SUBMITTAL IDENTIFICATION SHEET

WEBSTER UNIVERSITY ISB
PROJECT NAME

123553
SPECIFICATION SECTION / PARAGRAPH

COPIES	DATE	NO.	DESCRIPTION
1	1/25/17	04437AR1-E2 and 04337BR1-E4	Rough-In & Elevation Shop Drawings
1	1/25/17	04437DETAILS1 & 04437DETAILS2	Cabinet Sections
1	1/25/17	04437OHSC	OHSC detail/quantities Sheet
1	1/25/17	Set	Project Data Document

EPOXY RESIN SINK OUTLET
GRAPHITE

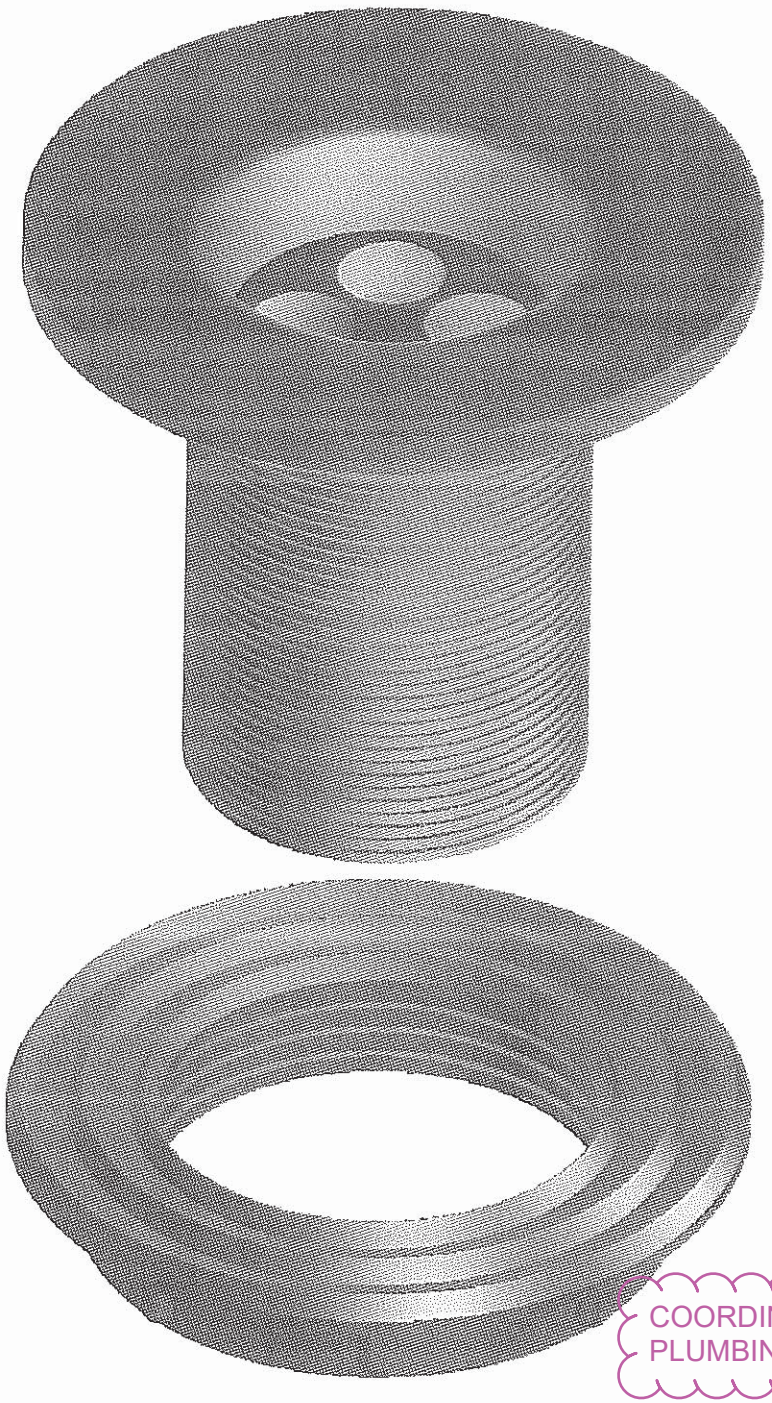
COORDINATE WITH PLUMBING DOCUMENTS.

PLUMBING TO REVIEW
